Stellaris® LM3S1627 RevA0 Errata

This document contains known errata at the time of publication for the Stellaris LM3S1627 microcontroller. The table below summarizes the errata and lists the affected revisions. See the data sheet for more details.

6.2 PB0 and PB1 have permanent internal pull-down resistance

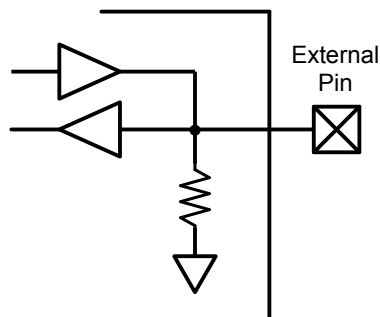
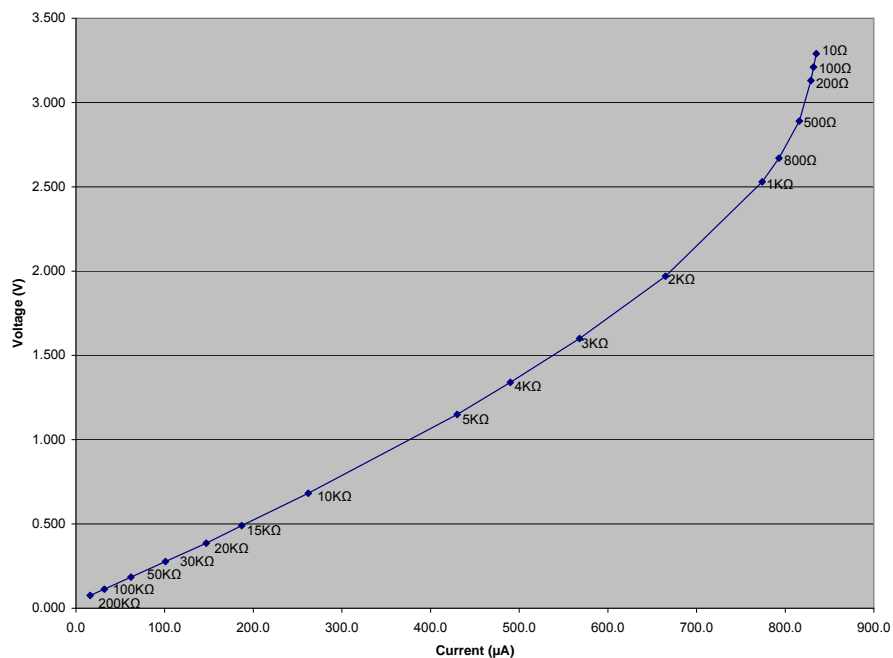
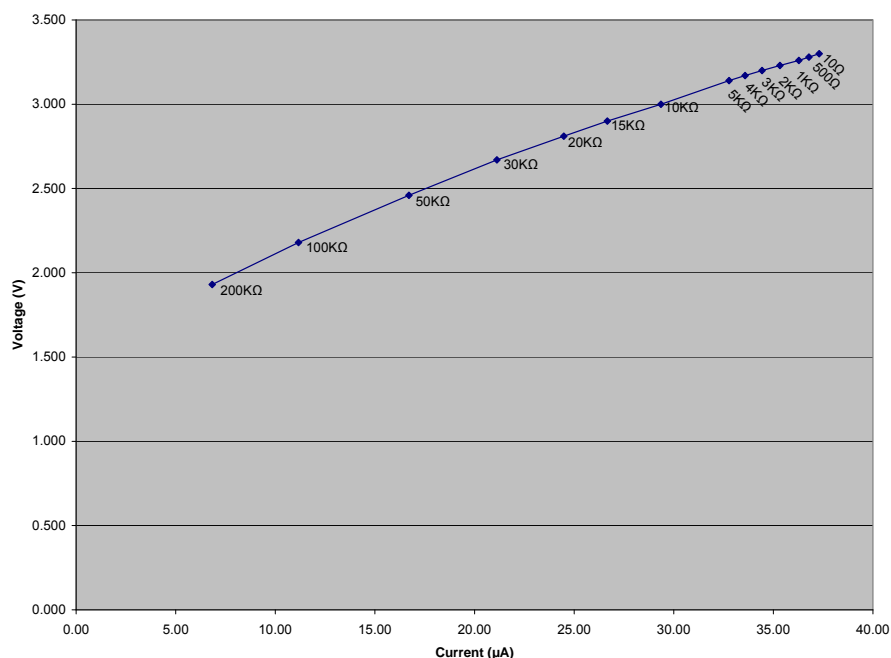
Regardless of their configuration, PB0 and PB1 have an internal pull-down resistance. The internal structure of these pins is shown in Figure 1 on page 8.

The characteristic of the pull-down for PB0 is shown in Figure 2 on page 9. The data labels for each data point show the external pull-up resistance in Ohms.

The characteristic of the pull-down for PB1 is shown in Figure 3 on page 10. The data labels for each data point show the equivalent resistance in Ohms.

When either of these pins is configured as an input, the external circuit must provide enough drive strength to over-drive the internal pull-down and achieve the necessary V_{IH} voltage level. If an external pull-up resistor is used, it must have a low value such as $\sim 1\text{ K}\Omega$ or less for PB0 and $\sim 50\text{ K}\Omega$ or less for PB1.

When either of these pins is configured as an output, the drive current needed to over-drive the internal pull-down resistance must be subtracted from the drive capabilities of the pin. In some applications, it may be necessary to select a higher drive strength (such as 4 mA instead of 2 mA) to achieve an acceptable output voltage on PB0.
